APPLICATION NO.	FILING DATE	FIRST NAMED INVENTOR	ATTORNEY DOCKET NO.	CONFIRMATION NO.
10/663,259	09/16/2003	Norman S. Martucci	79287.21520	1456
30734	7590	07/05/2007	EXAMINER	
BAKER & HOSTETLER LLP WASHINGTON SQUARE, SUITE 1100 1050 CONNECTICUT AVE. N.W. WASHINGTON, DC 20036-5304			AFTERGUT, JEFF H	
ART UNIT		PAPER NUMBER		
1733				
MAIL DATE		DELIVERY MODE		
07/05/2007		PAPER

Advisory Action Before the Filing of an Appeal Brief	Application No.	Applicant(s)
	10/663,259	MARTUCCI, NORMAN S.
	Examiner	Art Unit
	Jeff H. Aftergut	1733

THE REPLY FILED 21 June 2007 FAILS TO PLACE THIS APPLICATION IN CONDITION FOR ALLOWANCE.

FIG. 1

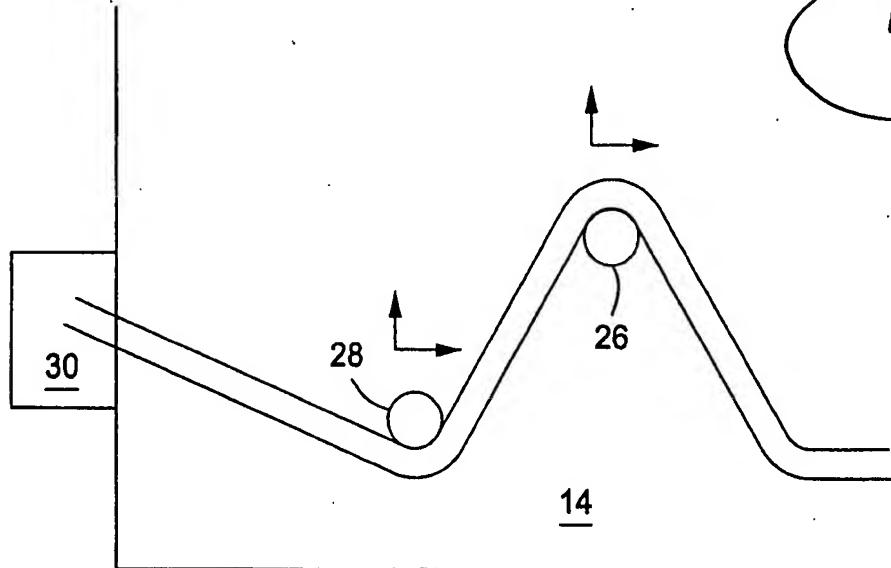
Continuation of 3. NOTE: Initially, it should be noted that the drawing changes (replacement sheets) have not been entered as Figure 1 of the replacement sheet does not include a bending device identified as 24 in Figure 1 of the original figures. Additionally, Figure 2 includes reference numerals 26, 28 which are identified as bending devices in Figure 1 and should be renumbered and reference to the same changed in the specification where appropriate. With regard to the proposed claims, it should be noted that the claims all require that the bending objects be "rotatable wheels". While the original disclosure did describe the bending objects as "wheels" it is not clear whether the original disclosure recited that these objects (wheels) were "rotatable". This raises a new issue regarding support in the original disclosure (i.e. whether applicant was in possession of the claimed invention under 35 USC 112, 1st paragraph). Additionally, limiting the bending devices to rotatable wheels creates a new issue which requires additional search and/or consideration. It should also be noted that amending the claim in the fashion proposed raises some concerns regarding how claim 17 further defines claim 13 as claim 13 already has presetned the reservoir for the polymeric material. .

FIG. 2

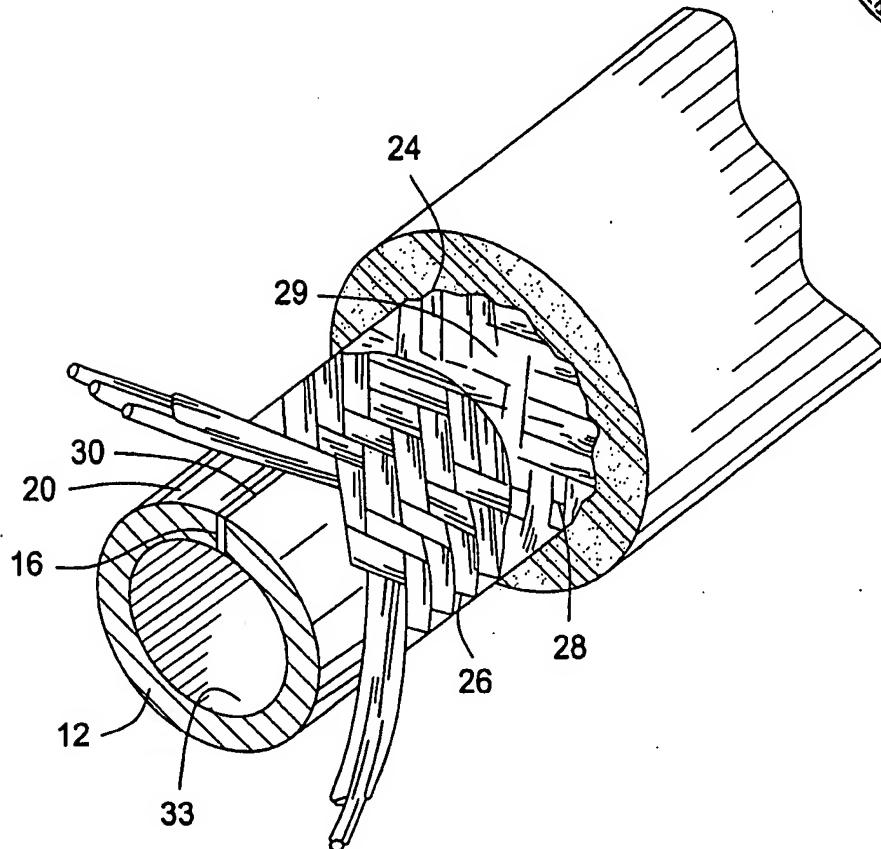
Not APPROVED!
